CITY OF ALBUQUERQUE

RE: **Lot 19 Block 9 Unit 22 SAD 228
6508 Canavio Rd. NW
Volcano Cliffs Subdivision
Grading and Drainage Plan
Engineers Stamp Date 3/30/2021 (D10D003I19)**

DRAINAGE AND TRANSPORTATION INFORMATION SHEET (REV 6/2018)

ENGINEER'S SEAL 3/30/21 DAVID SOULE P.E. #14522	6508 CANAVIO	DRAWN BY: WCVJ
	GRADING AND DRAINAGE PLAN	DATE: 3-18-21
 1606 CENTRAL AVENUE SE SUITE 201 ALBUQUERQUE, NM 87106 (505) 872-0999		210210027-LAYOUT-3-18-21
		SHEET #
		JOB # 21021027

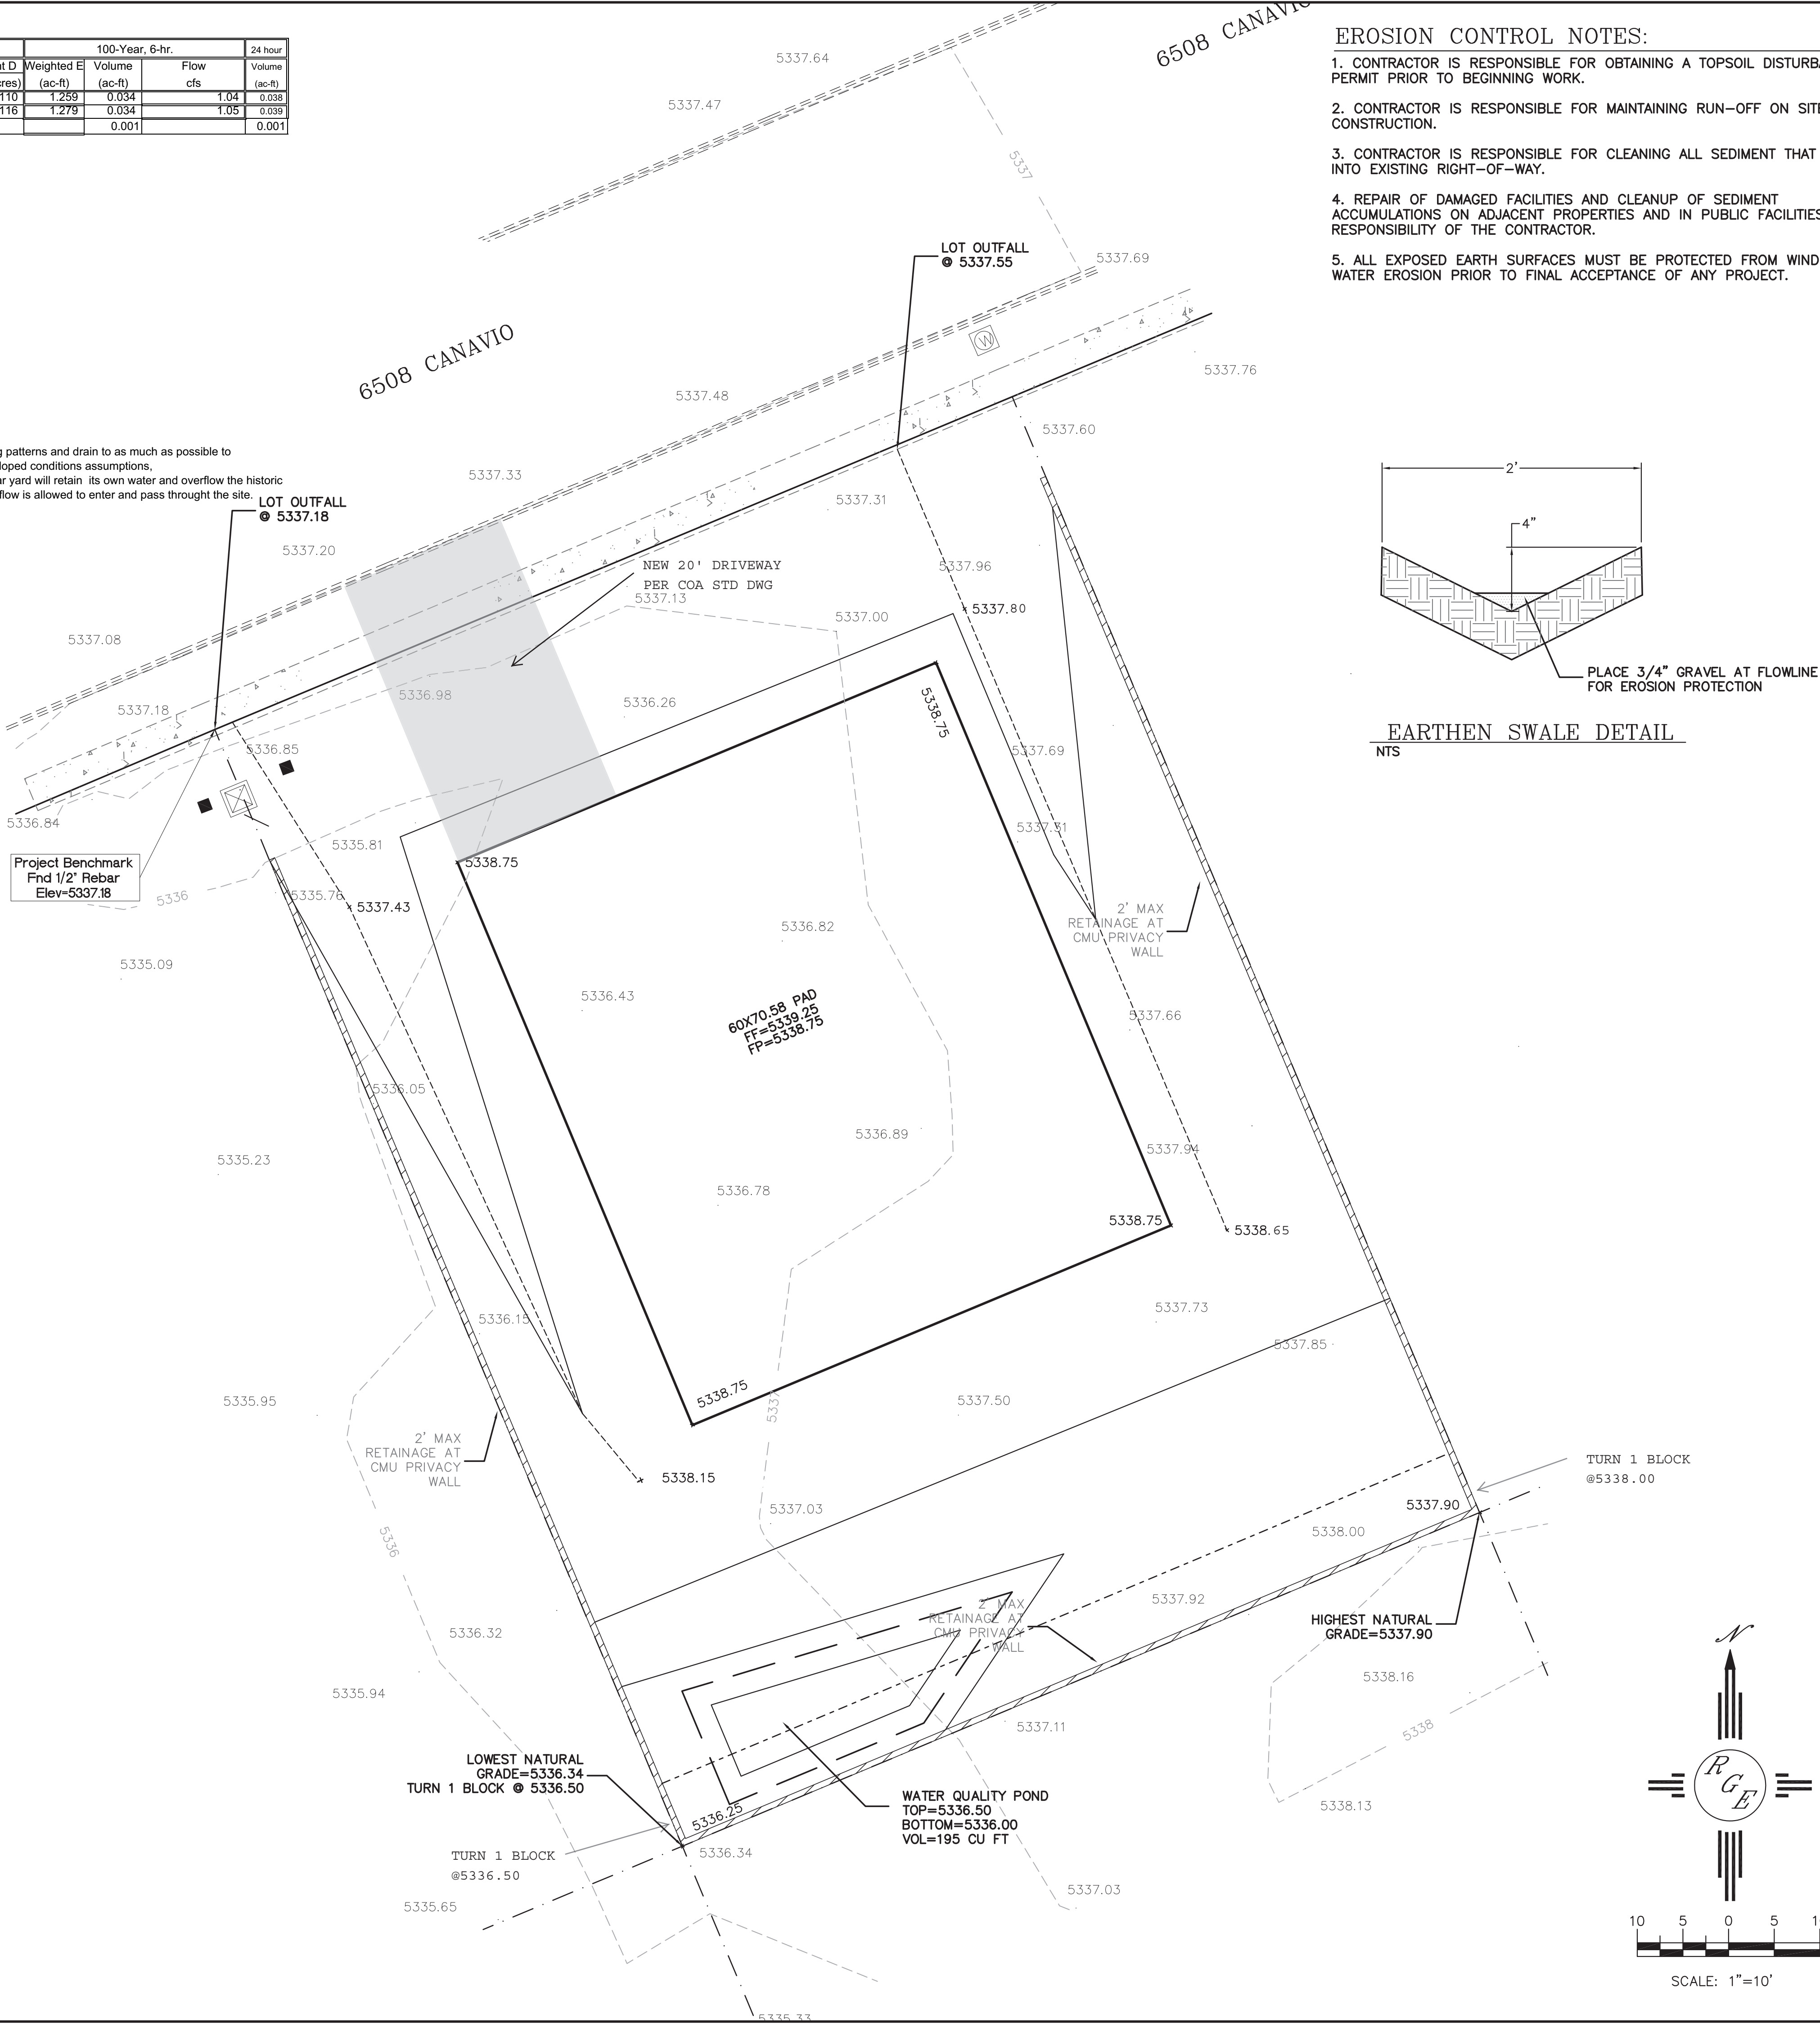
Based upon the information provided in your submittal received 3/30/2021, this plan is approved for Grading Permit.

Prior to Building permit approval a Pad Certification will be required, provided by the Engineer or a registered Land Surveyor.

Advise the owner contractor not to use dirt as a ramp to climb the curb, use lumber or crusher fines for this purpose.

Reiterate to the Owner/Contractor that a separate permit for a garden/retaining wall must be obtained with the approved G&D plan and Pad Certification. Also, if a swimming pool is to be placed the grading and drainage plan will change and will need to be resubmitted.

Prior to Certificate of Occupancy release, Engineer Certification per the DPM checklist is required.
